No.: 08 TS-9
April 15, 2008

SUBJECT: **EPA98 and EPA04 MBE 4000 Cylinder Block Heater Element and Cord Inspection**

Figures 1 and 2 – EPA 98 MBE 4000 Engine Block Coolant Heater Element Location

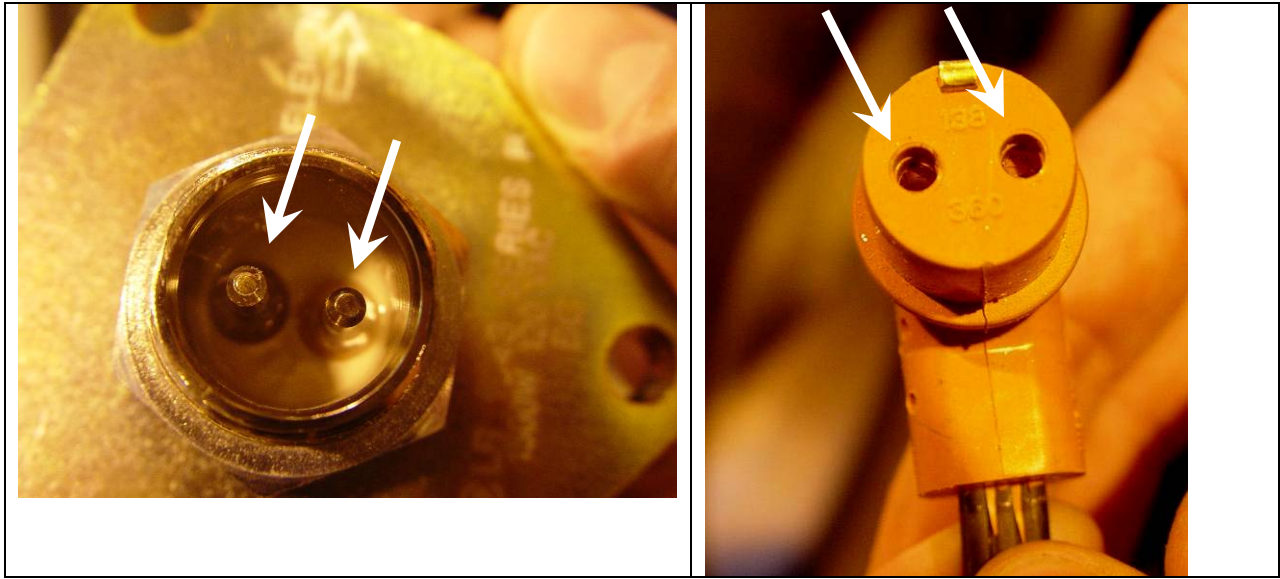
- All EPA98 MBE 4000 engines have engine block coolant heater elements installed on the left side of the engine. See Figures 1 and 2.
- Move engine block coolant heater elements installed on all EPA98 MBE 4000 engines from the left side of the engine to the right side and replace as necessary. See Figures 1 and 2 for left side (current) location.
- All EPA04 MBE 4000 engines have engine block coolant heater elements installed on the right side of the engine. Inspect and replace as required.

**Figure 9 - Block Coolant Heater Orientation**

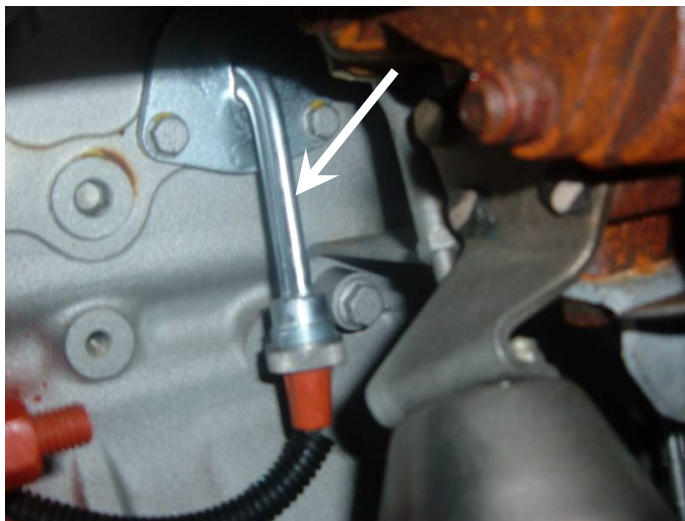
3. On EPA98 engines, install the existing block heater element (if undamaged) or new block heater element on the RIGHT side of the engine if the suitable mounting pad is present on the cylinder block. See Figures 7 and 8.

- a. Drain cooling system.
- b. Remove the cover plate from the right side of the block and discard the gasket. Save the cover plate for relocation to the left side of the block.
- c. Install the block heater element with a new gasket on the RIGHT side of the block. If you are using a new block heater element, it will come with a new gasket. The coiled wire of the block heater element will point to the front of the engine when inserted into the block, with the electrical connection pointing to the ground. See Figure 9. Torque the three M8 x 20 mounting bolts to 30-38 N·m (22-28 lb·ft).

Figure 14 – EPA98 Main Fuel Return Line Inspection

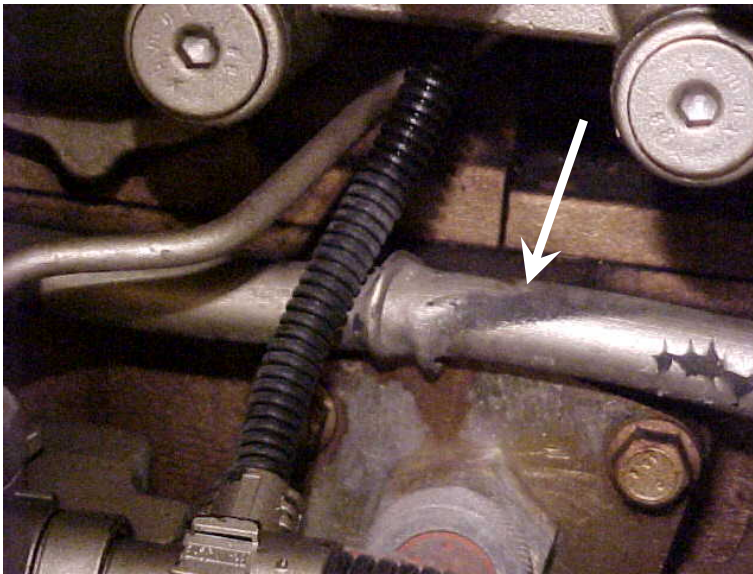
4. On EPA98 engines, inspect the main fuel return line located just above the former block heater element location on the left side of the block. Replace the line if any damage is noted. See Figure 14.
